## RESPONSES TO ENERGY PROBE RESEARCH FOUNDATION INTERROGATORIES ON ISSUE 2. 2

1 **INTERROGATORY 28:**

2 **Reference(s):**           **Tab 4, Sch. B6 Rear Lot Construction**

8 **Figure 1 – Outage Frequency for Rear Lot Overhead and Underground Service**

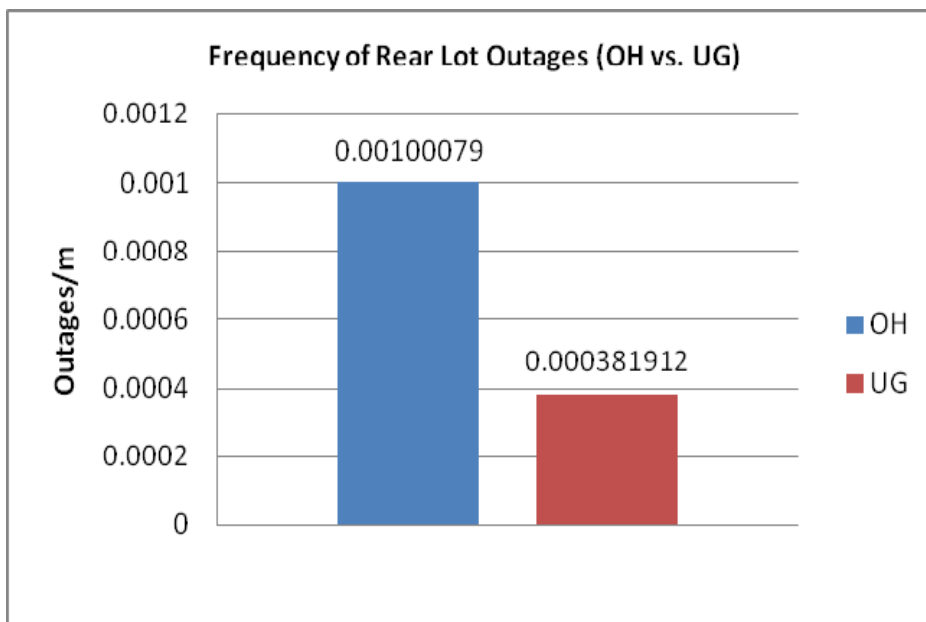
4 Page 5 Lines 9-17 discuss outages of rear lot overhead lines. Lines 12-13 state that  
5 “Typical outage restoration times for rear lot plant outages are more than twice those of  
6 front lot outages”.

8 Does this statement assume overhead in both rear lot and front lot? If not, please explain  
9 what is being compared.

12 THESL is revising the cited reference and modifying Figure 1 that follows to clarify the  
13 information presented. The changes and modified Figure 1 are provided below with  
14 changes noted in red. The changes, however, do not impact the quoted statement. That  
15 statement refers to the comparison of the average CAIDI for a sample of rear lot outages,  
16 which contain a mix of overhead and underground service, compared to the system  
17 average CAIDI, which also represents a mix of overhead and underground service as  
18 discussed in Tab 4, Schedule B6, page 7 at lines 17-22. The reasons for this difference  
19 are explained throughout Tab 4, Schedule B6 in terms of the difficulties in working on  
20 rear lot equipment. In particular, pages 28-29 of Tab 4, Schedule B6 describe some of  
21 the extremely long duration outages experienced by customers with rear lot service.

1 reliable and reduce maintenance costs compared to their overhead counterparts.<sup>1</sup> Typical  
2 outage restoration times for rear lot plant outages are more than twice those of front lot  
3 outages. Thus, customers supplied via the rear lot may experience outage durations that  
4 are much longer than normal. Additionally, the likelihood of an outage occurring **on the**  
5 **overhead system** is significantly higher. The **Figure** below **compares** the **frequency of**  
6 **outages per meter of rear lot overhead service with the frequency of outages per meter of**  
7 **rear lot underground service.**
